DESCRIPTIVE REPORT

Registry No. H-11098

General Locality Kasaan Bay

Sublocality Skowl Point to Baker Point

Figure 3.0

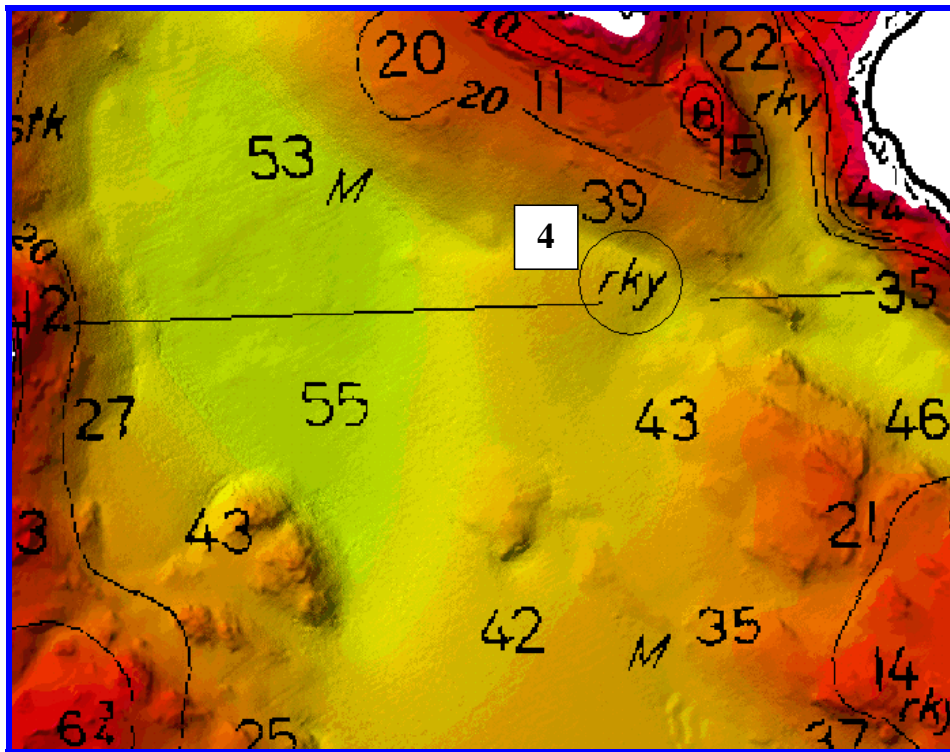
Vicinity	Comment
(4)55°30'01"N and 132°23'21"W	Area marked as rocky(rky) is generally featureless.

Based on the results of survey H-11098, the Hydrographer recommends removal of the rky symbol located at 55°30'01"N and 132°23'21"W on the affected charts.³³

- ³² Concur.
- ³³ Concur.
- ³⁴ Concur. Also note that there were numerous errors in the depiction of contours on the smooth sheet. Errors have been corrected on the Hdrawing.

Portion of chart 17426 compared to survey H-11098 soundings and contours

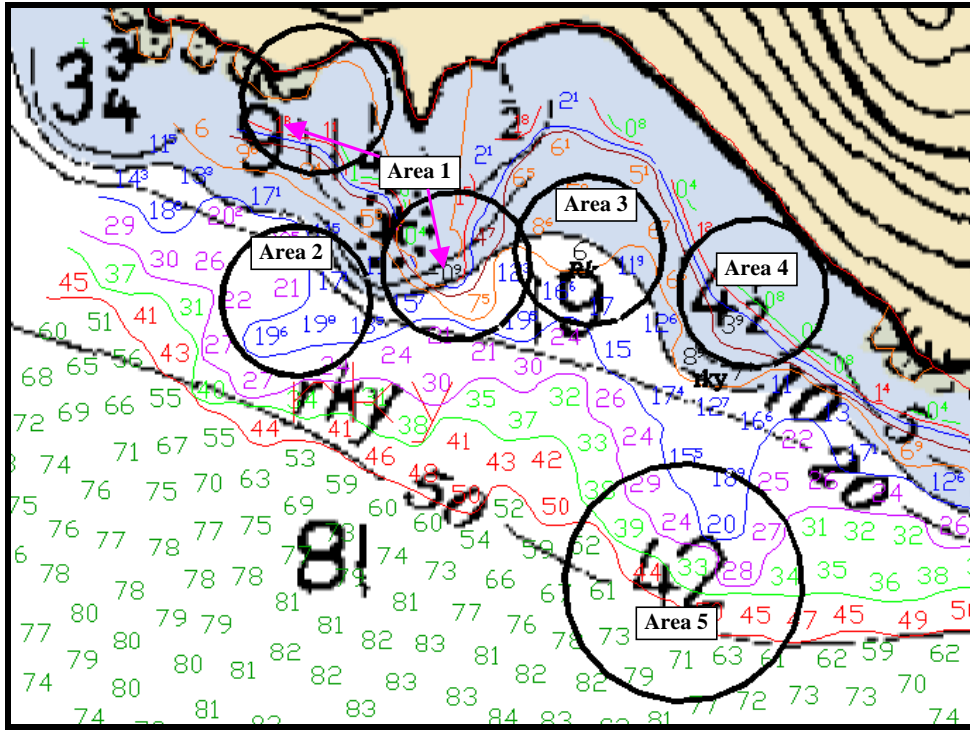
Vicinity	Comment	Location Index
Area 1 Copper Queen Reef 55°31'58"N and 132°23'30W 55°31'45"N and 132°22'44"W	A 1.8 fathom sounding at the same location as a charted 9 fathom sounding. A 0.8 fathom sounding at the same location as a 5 ½ charted fathom sounding. A danger to navigation report was submitted. ³⁶	<i>C-1</i>
Area 2 55°31'51"N and 132°23'32"W	The 20 fathom contour line is advancing 125 meters.	<i>C-1</i>
Area 3 55°31'54"N and 132°23'12"W	A rock with a depth of 6 fathoms on the deep side of the charted 10 fathom curve. ³⁷	C-1
Area 4 55°31'51"N and 132°23'03"W	A 3.9 fathom sounding at the same location as a 4 ½ charted fathom sounding.	C-1
Area 5 55°31'44"N and 132°23'04"W	The 20 fathom contour line is advancing 135 meters.	C-1

- ³⁶ Do not concur. The position is not within the area as illustrated. A sounding of 5½ fathoms is charted at the position given, but there is no nearby smooth sheet sounding of 0.8 fathoms. The closest smooth sheet sounding to the position is 7.1 fathoms. No Danger to Navigation report was submitted for this position.

- ³⁷ Concur with clarification. This sounding was reported as a Danger to Navigation, 6 fathoms at Lat. 55 31 53.6N, Lon. 132 23 12.0W.
- ³⁸ Do not concur. This is the same position and charted sounding discussed in endnote 36. There is no nearby smooth sheet sounding of 0.8 fathoms.

Light List Position for Kasaan Log Boom Buoys (22385) on chart 17426

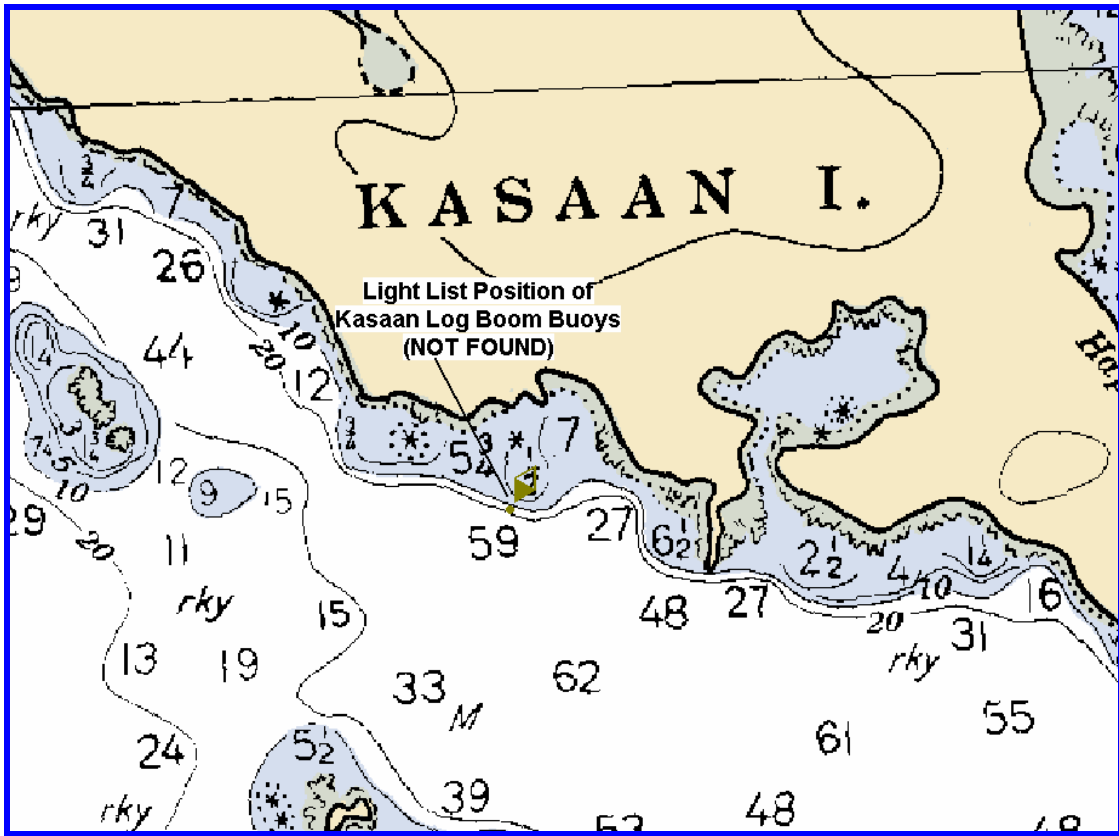
<u>USCG Light list name</u>	Kasaan Log Boom Buoys (3)	
<u>Name on chart</u>	Not on chart	
<u>USCG Light list number</u>	22385	
<u>Characteristic</u>	N/A	
	<u>Height</u>	N/A
<u>Range</u>	N/A	
<u>Structure</u>	White and orange buoys worded DANGER LOG BOOM.

Evaluator Comment: Retain floating/anchored log boom notation on Chart 17426.

Portion of Chart 17420 showing the misspelling of geographical names

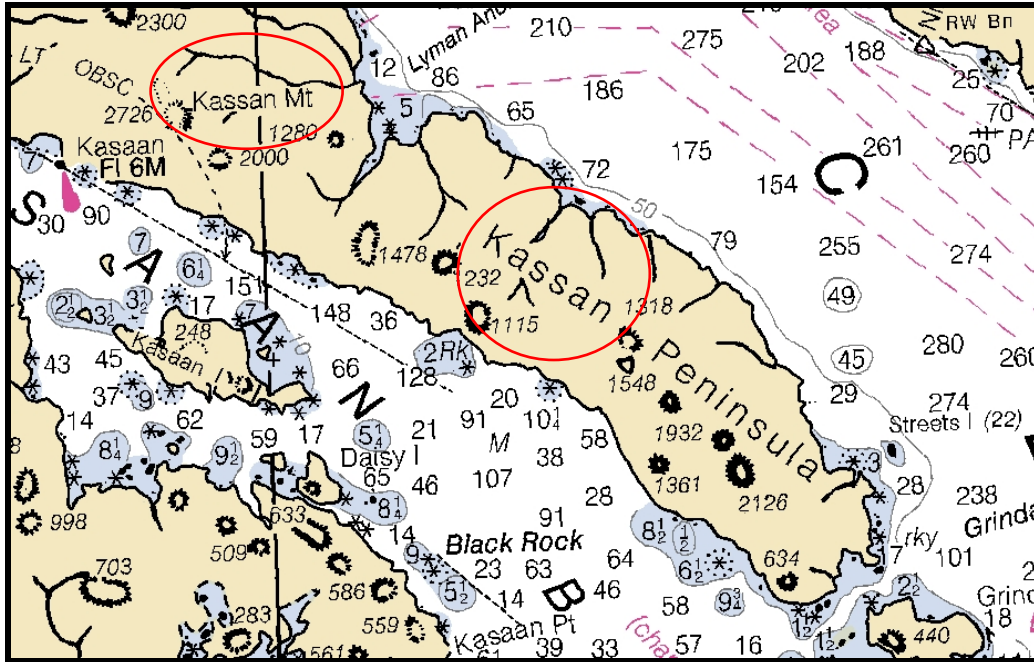
The geographic names Kasaan Peninsula and Kasaan Mountain were found to be misspelled as *Kassan Peninsula* and *Kassan Mountain* on Chart 17420. Local knowledge and all other references found for the area support the proper spelling as Kasaan Peninsula and Kasaan Mountain.¹⁰¹

¹⁰¹ Concur. Correct charted geographic names as applicable.
